Final sign-off of Site Plan - EPC for development of Tract 4 of North Andalucia at La Luz with a 171 unit senior, age-restricted multi-family residential development.

RE: Andalucía Senior Housing Site Plan and Related Applications

PROJECT NUMBER: PR-2020-003658
Application Number: SI-2020-00357

Re: Overture Andalucia (PR-2020-003658, SI-2020-00356) Final Site Plan Sign-off

REFUSE ENCLOSURE DETAILS

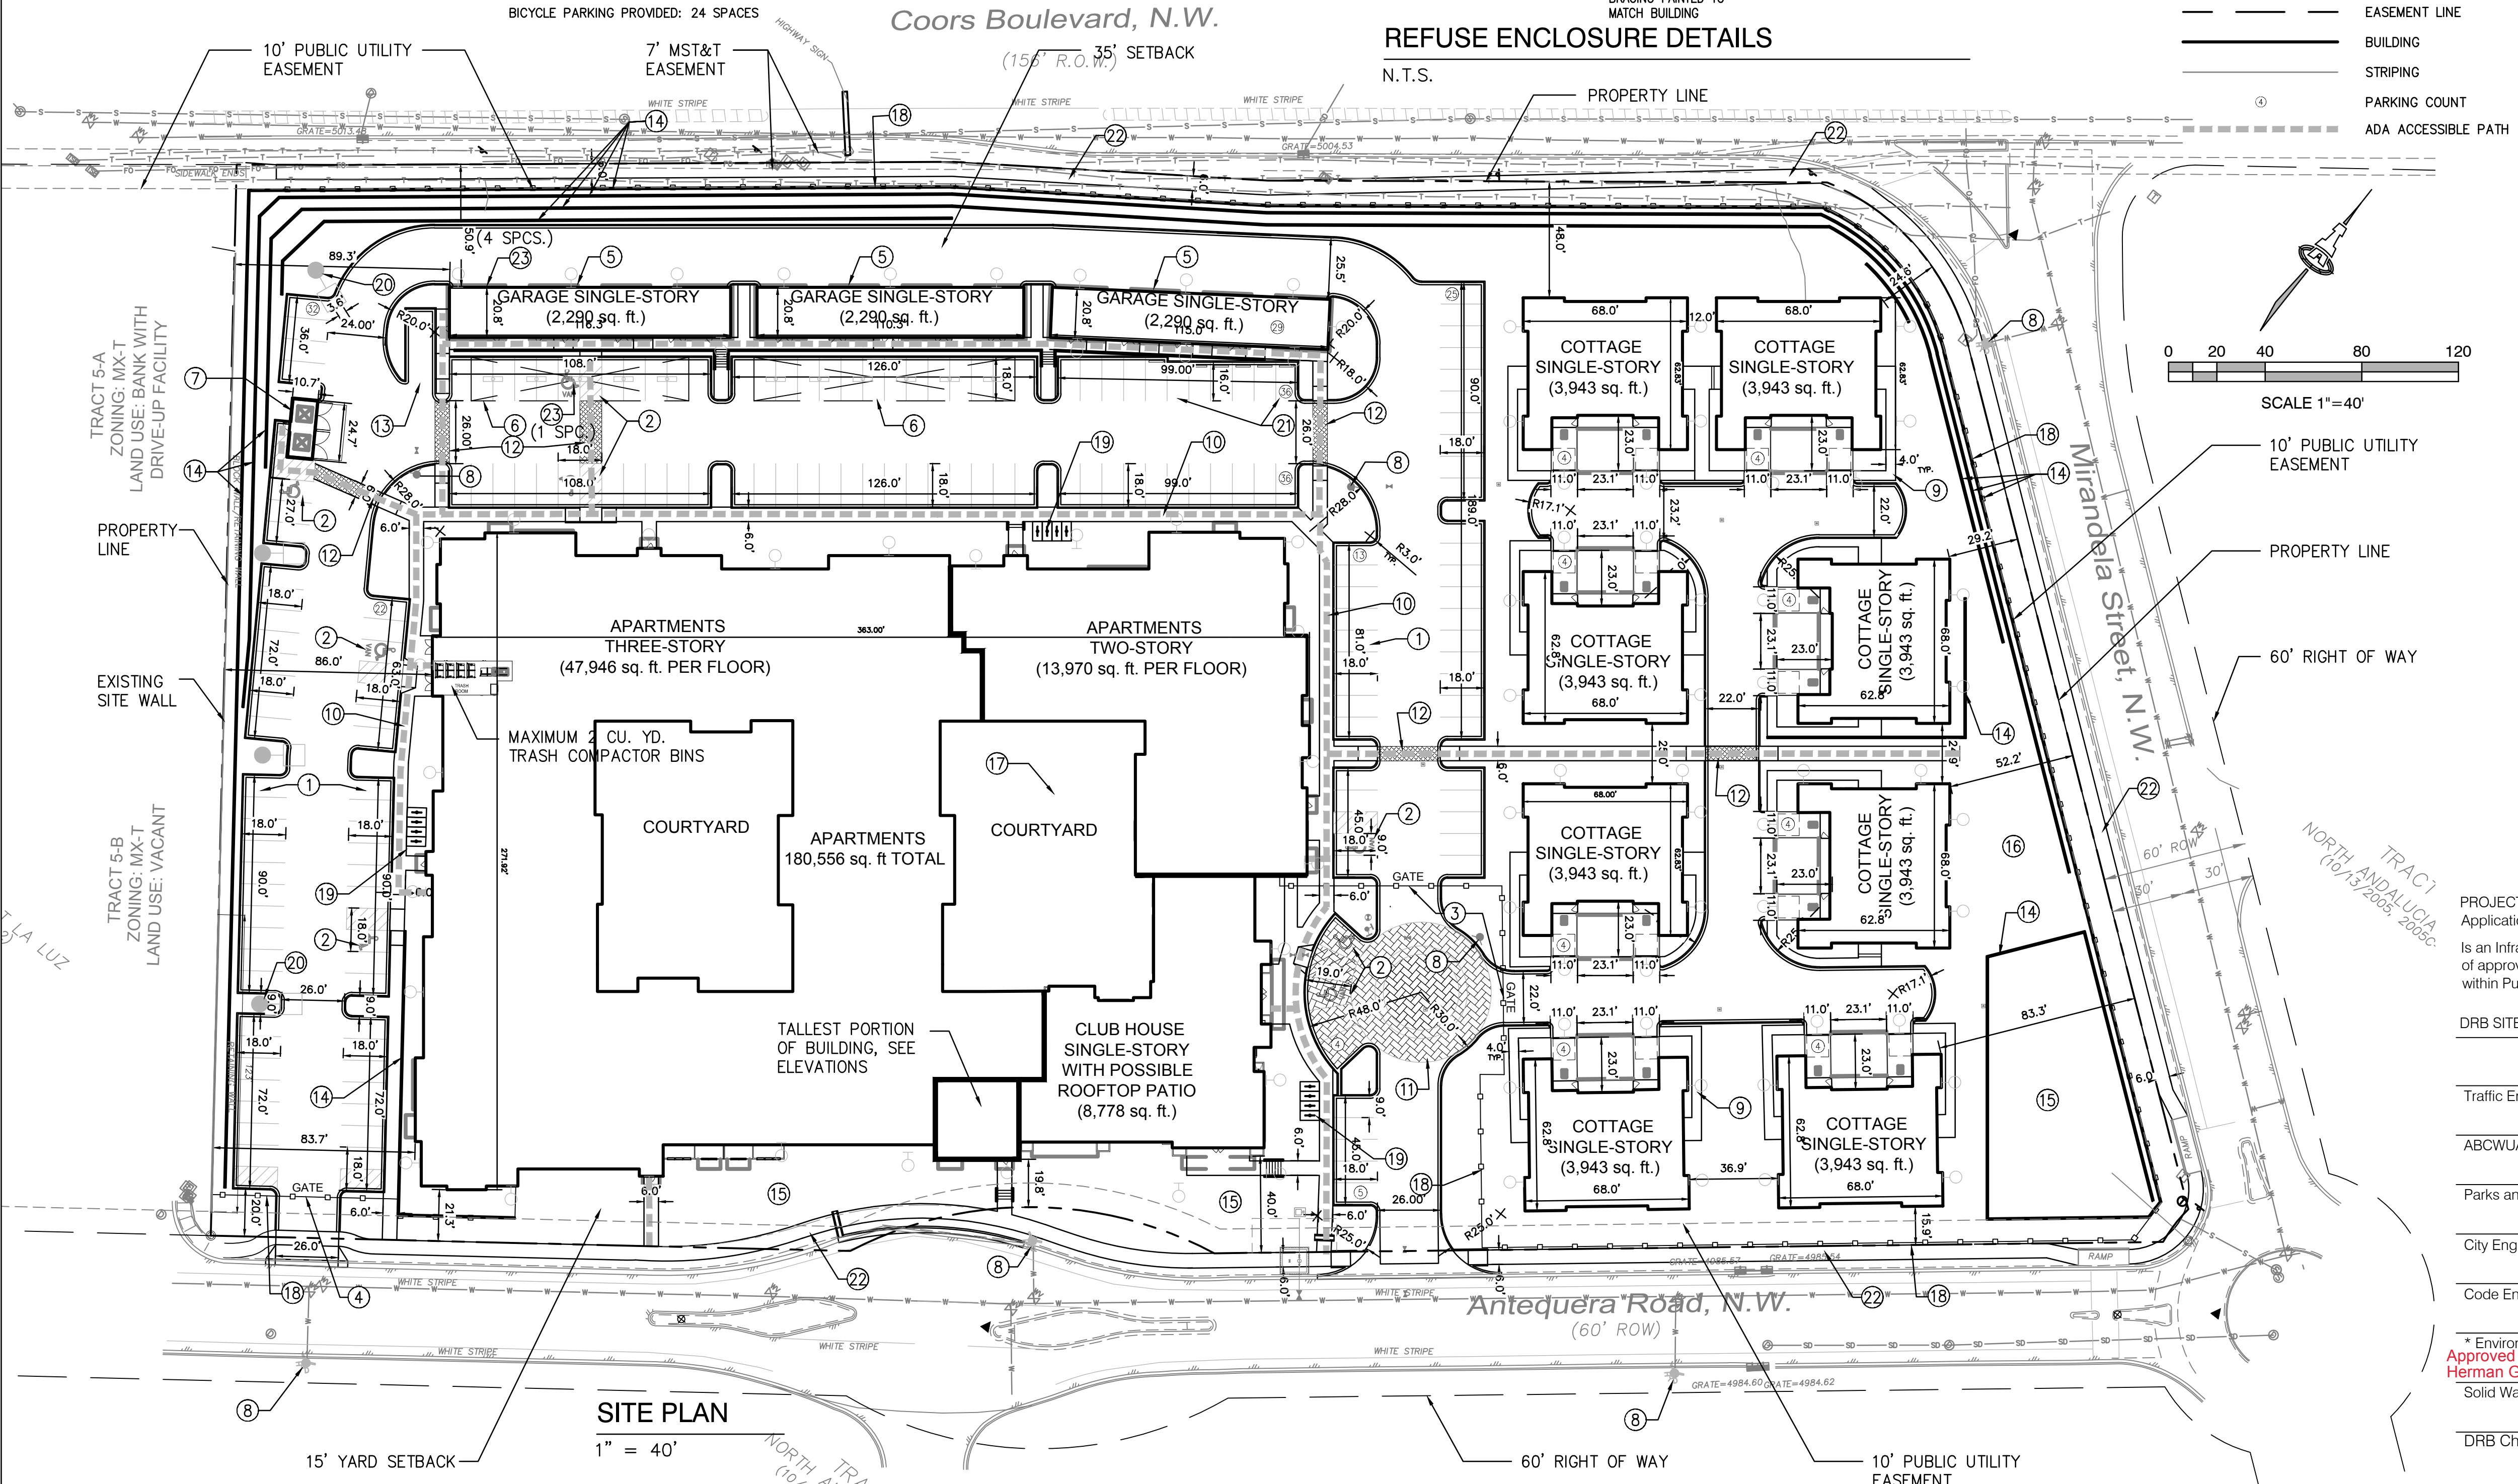
6. Refuse enclosure gate indicates painted wood cedar. More durable material such as painted Hardie board, shall be used.
7. Grading and Drainage:
 - Where acceptable to City Hydrology, show curb cuts for water harvesting.

The refuse enclosure detail on the Site Plan has been updated to reflect the use of Hardie board or equivalent durable material.

**EXHIBIT - PERIMETER
 WALL SECTIONS**

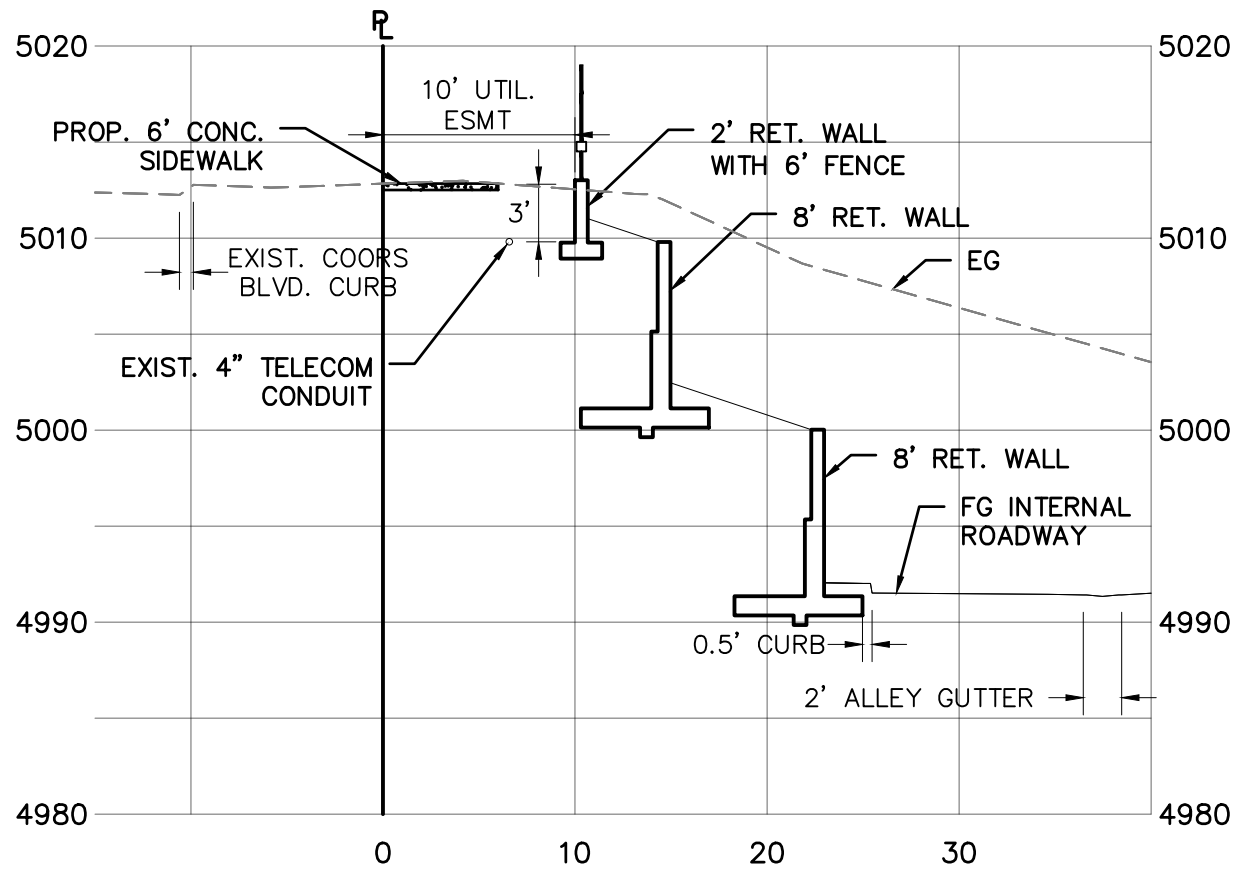
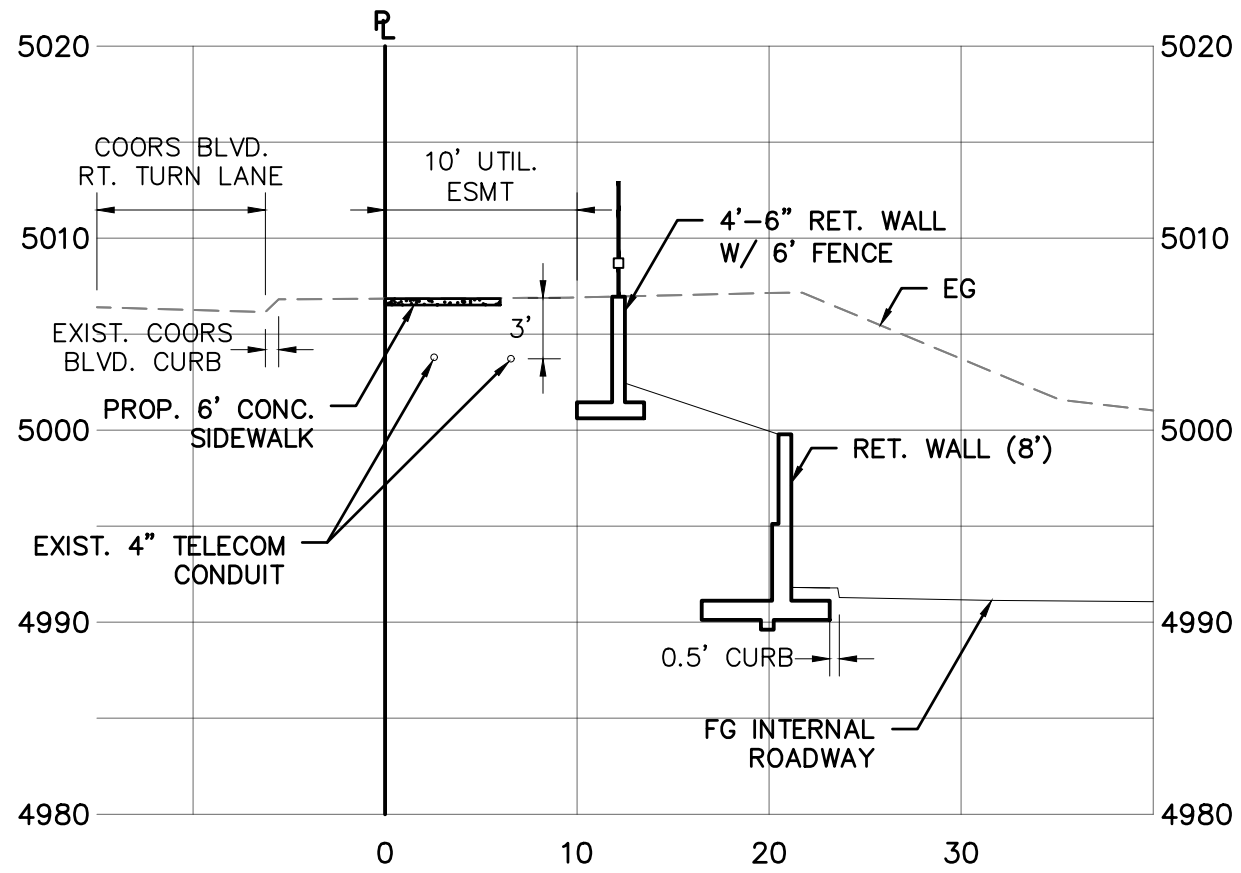
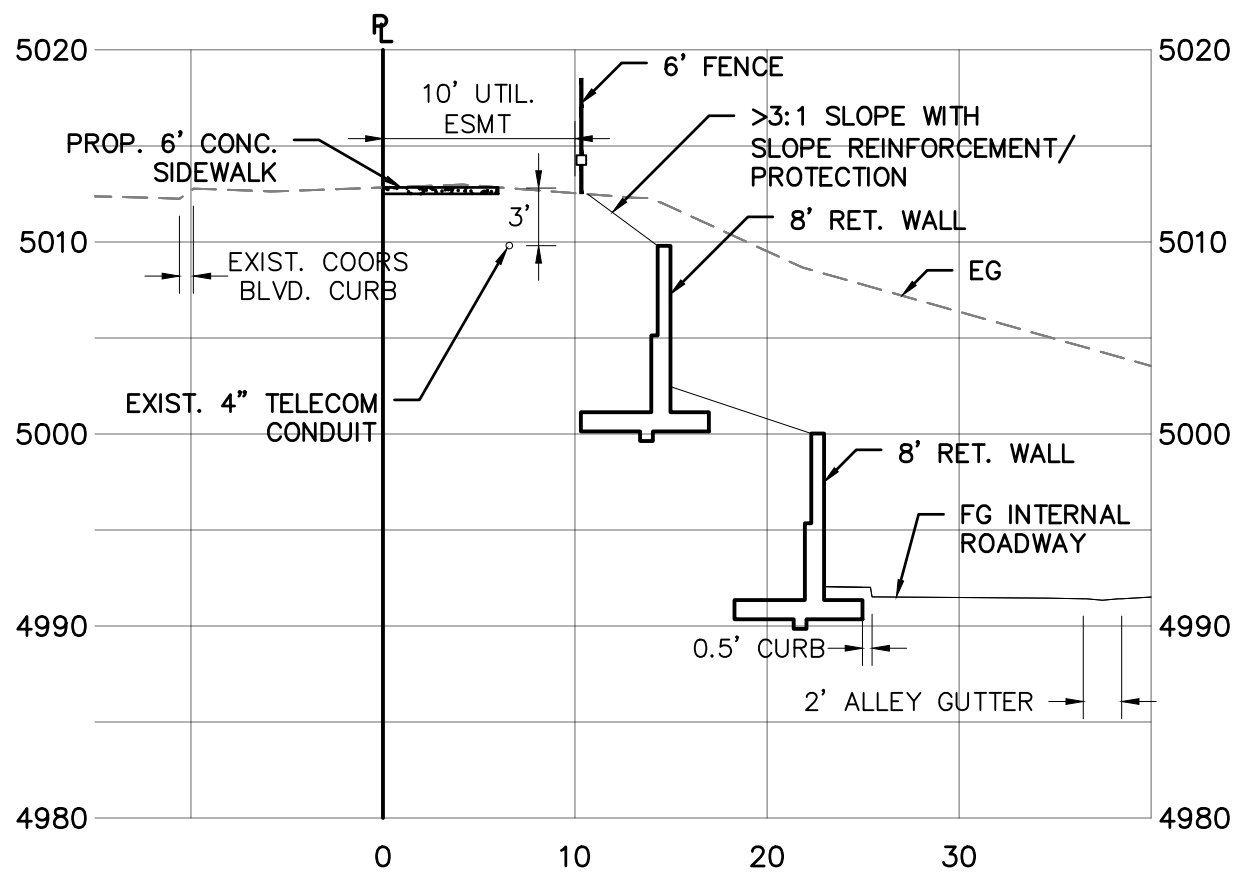
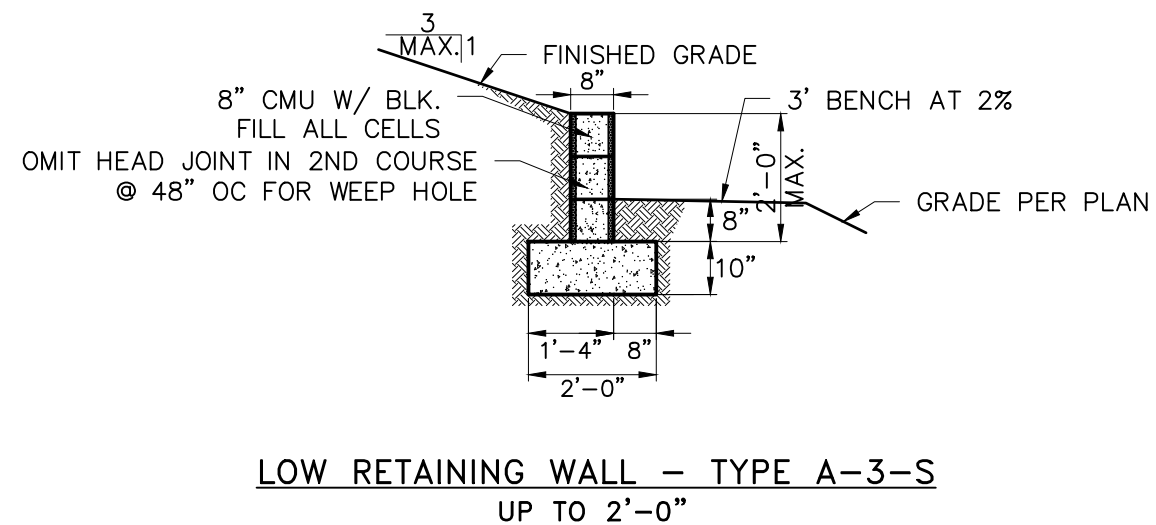
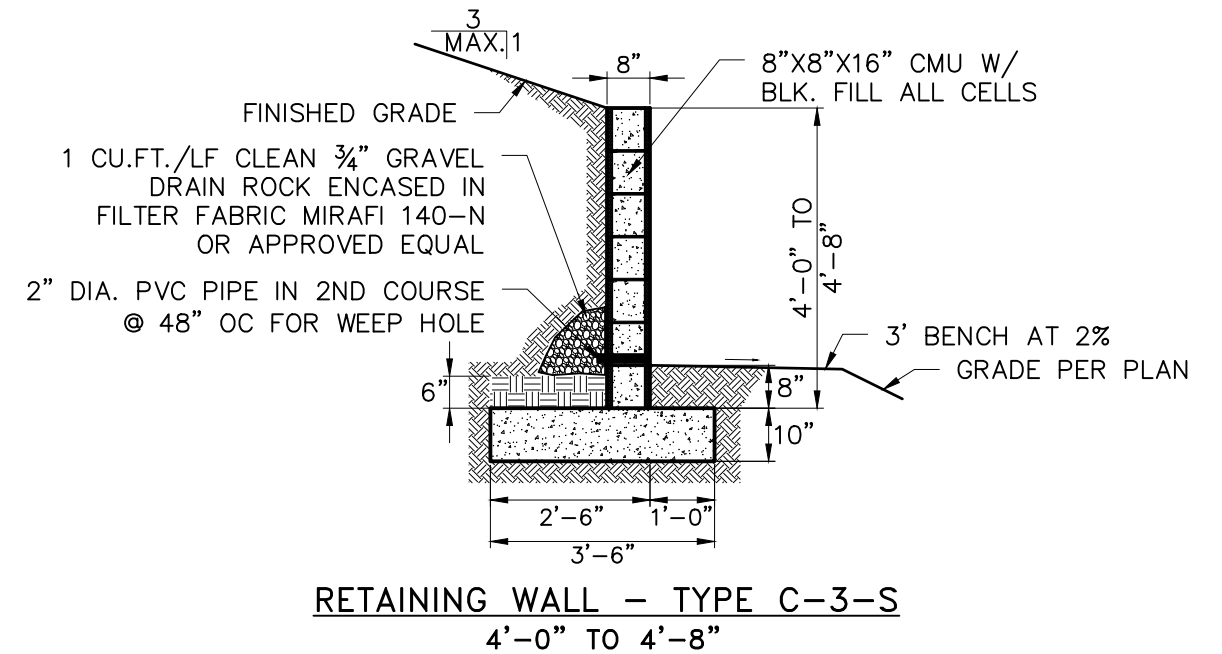
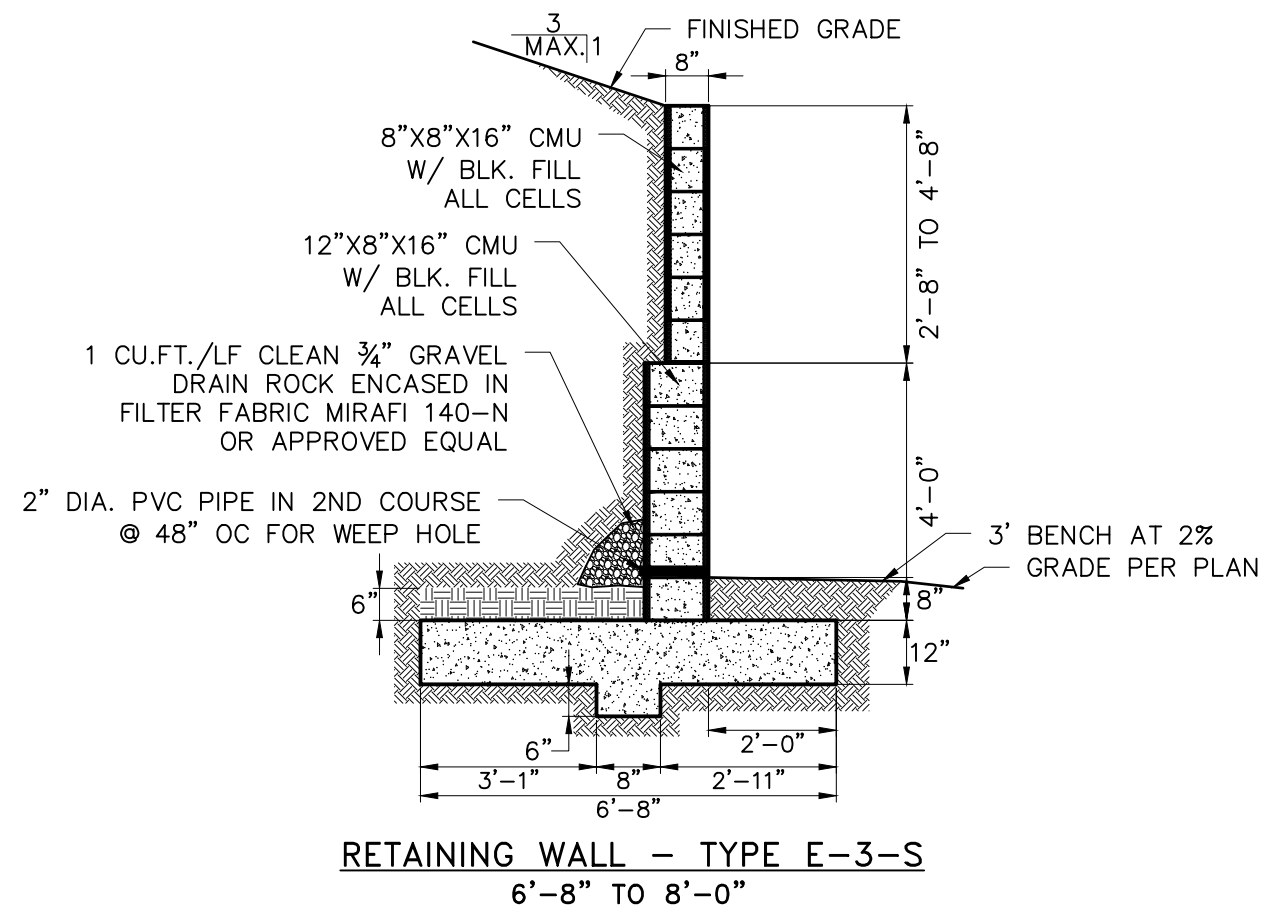
5. The retaining walls indicated on the plan do not have accompanying details. These shall be provided and then reviewed and approved through DRB prior to building permit.

5. The retaining walls indicated on the plan do not have accompanying details. These shall be provided and then reviewed and approved through DRB prior to building permit.

Retaining wall detail drawings have been included for DRB review.
